Recommendation Report on an Outdoor Game Court
Prepared by Department of Planning
for the
City of Wildwood Planning and Zoning Commission
December 19, 2016 Executive Session
"Planning Tomorrow Today"

P.Z. 4-16 Scott Fieser, 10 Whitsetts Fork Ridge Road, Wildwood, Missouri, 63038, is seeking a second review and action of the Planning and Zoning Commission on an outdoor game court (full court basketball court, with lighting), which is located at 10 Whitsetts Fork Ridge Road, Wildwood, Missouri (Locator Number 24V430121)); NU Non-Urban Residence District. This request is to be reviewed in accordance with Chapter 415.090 NU Non-Urban Residence District Regulations of the City of Wildwood Zoning Code, which establishes standards and requirements for outdoor game courts relating to their consideration by the Planning and Zoning Commission. The game court and lighting is currently installed, without Planning and Zoning Commission approval, and situated to the west of the single family residence located on the subject property. The Department will have a recommendation report prepared for consideration at this meeting for this request. **(Ward Six)**

Subject: City of Wildwood Lighting Or

LANDSCAPE DEVELOPMENT PLAN FOR
FIESER RESIDENCE
10 Whitsetts Fork Ridge Road
Wildwood, MO 63038
636-262-7855 scottfieser@hotmail.com

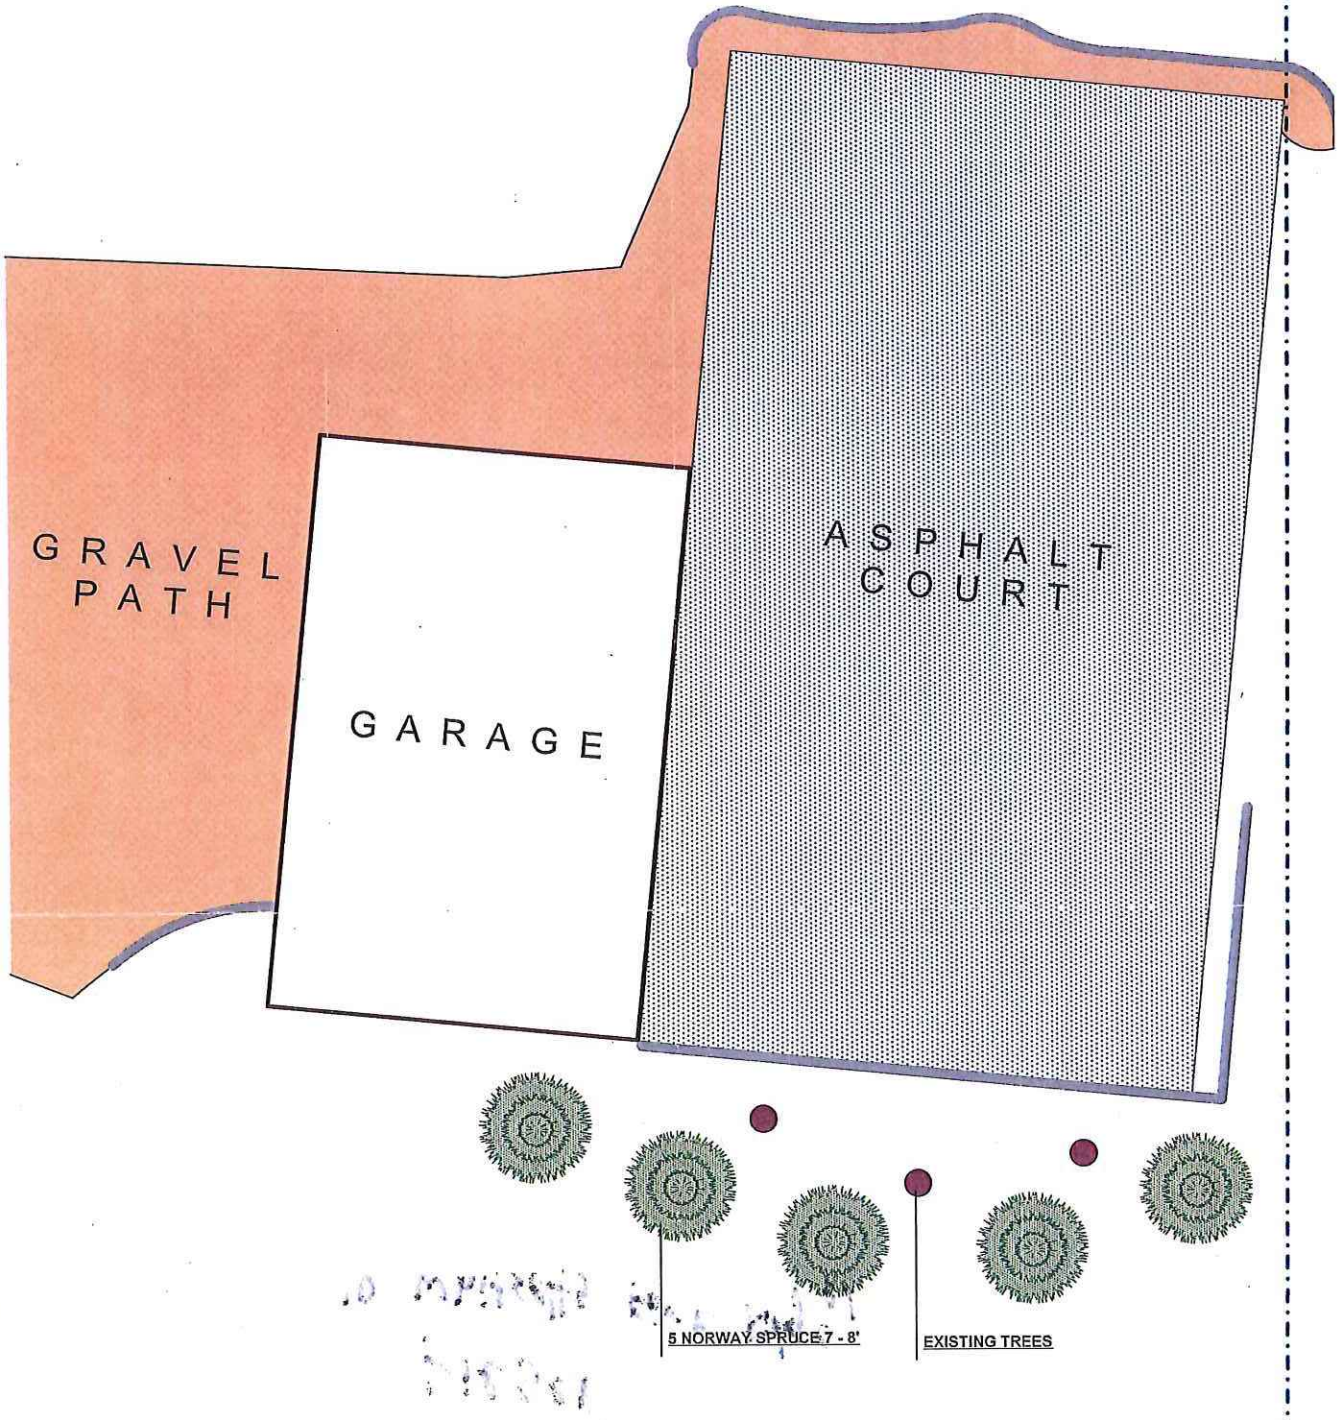
1) Section 415.090 (L) 1 requires landscaping in association with outdoor game courts to provide a visual screen from adjacent parcels of ground.
2) Five (5) Norway Spruce Trees are proposed to be placed above the grade of the installed outdoor game court and below the grade of Whitsetts Fork Ridge Road to provide screening from the private street. This proposed landscaping must be reviewed to ensure compliance with the City's Tree Manual and Sustainable Plantings Guide.

3) No landscaping is currently proposed along the southern or western lengths of the court. Landscaping shall be provided along the western length of the court, where the existing retaining wall is not present. Landscaping shall not be required, where existing woodlands are located on this western boundary line.

4) A landscape plan must be prepared by a landscape architect or reputable nursery and submitted to the City for review to ensure compliance with Section 415.090(L) and the City's Tree Manual and Sustainable Plantings Guide.

LS-1

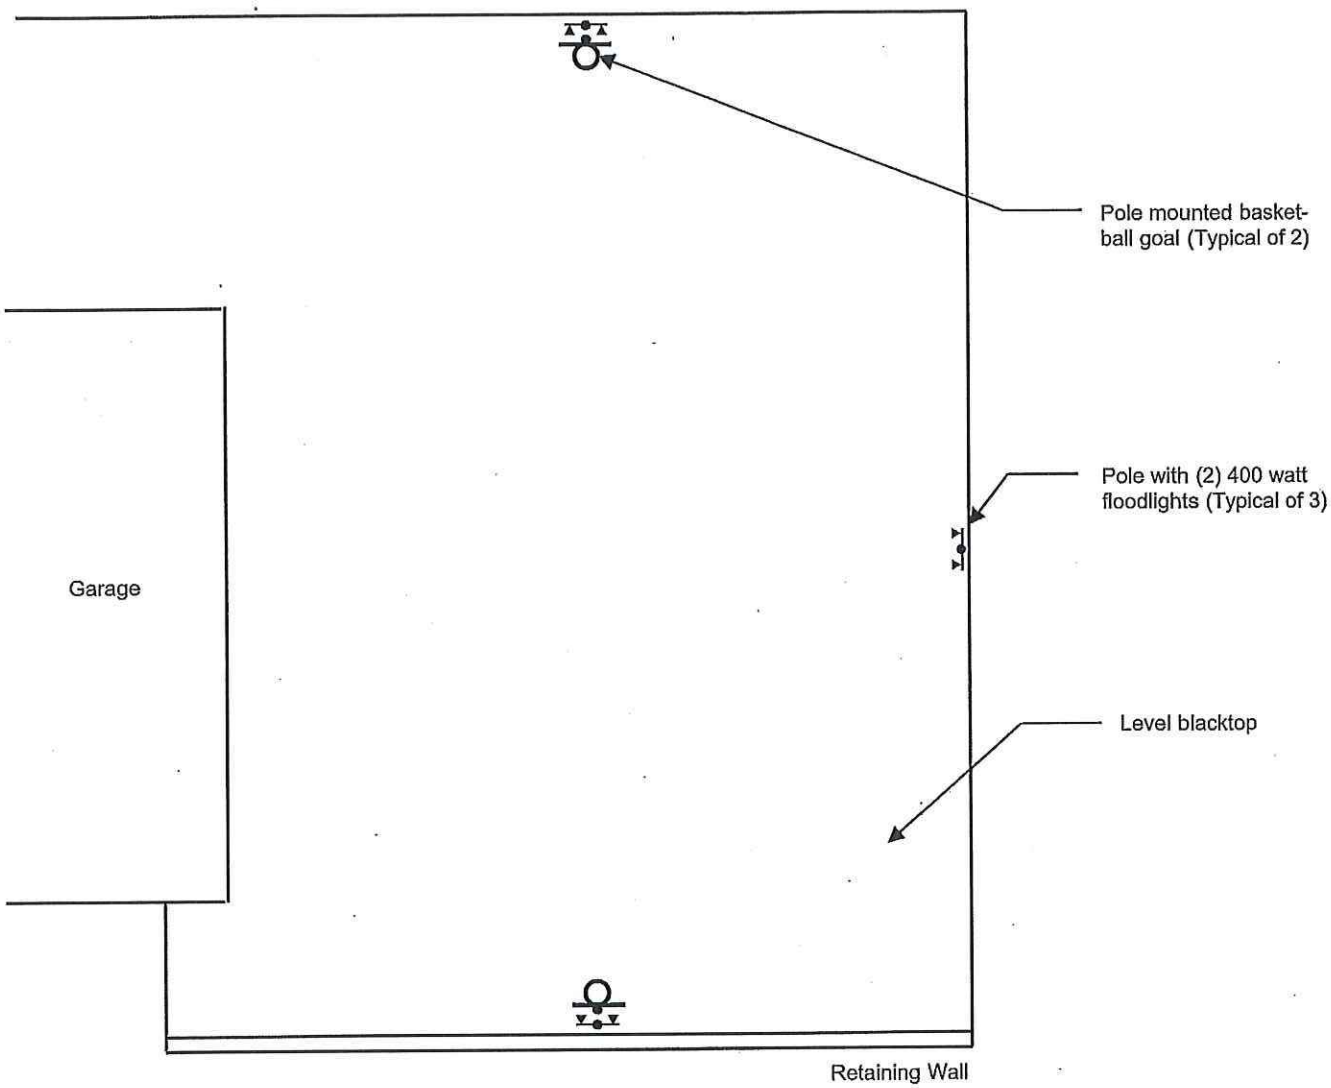
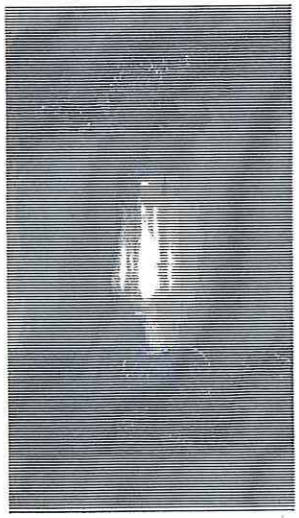
The lighting in question is associated with a level blacktop playing surface equipped with two (2) standard height pole mounted backboards and nets, one mounted at each end of the playing surface. There are two (2) 400W metal halide floodlights atop (nominal) 25'-0" poles at the (approximate) center line of the north, south, and west sides of the playing surface. Properties to the south are, generally, at a lower elevation than the court, while properties to the north are higher. A sketch is attached for reference.

The pole mounted floodlights are focused onto the court surface at an angle that introduces the lamp (bulb) to the eye at normal viewing angles creating significant glare. Photos included.

Given that a plane of play exists at the basketball goal (net), which is 10 feet above the playing surface, and that the ball may routinely eclipse 16'-0" above the playing surface, it is impractical to use a maximum 16'-0" pole to provide light, if the court is accepted as a sporting location.

The existing fixtures, however, do not exhibit good glare or light control, nor are they focused (aimed) in an acceptable manner to minimize light trespass or light pollution.

2. The existing fixtures would not, in our opinion, be acceptable for use as currently outfitted. The fixtures do not include any significant optical control and, therefore, light travels indiscriminately across property lines and skyward. Additionally, aiming angles create undesirable glare from adjacent property.

1. The existing 25'-0" poles should be reduced to 20'-0" in height. (Note: 16'-0" poles are insufficient height for safe nighttime play).

a) Replace existing fixtures with new units that have better optical and cutoff capabilities. Tailor optics for the court. RECOMMENDED

b) Focus existing fixtures downward so that lamp is parallel with playing surface plane. Add external glare control devices to minimize/eliminate upward directed light, light crossing property lines, back directed light. This may be achievable but not easily so.
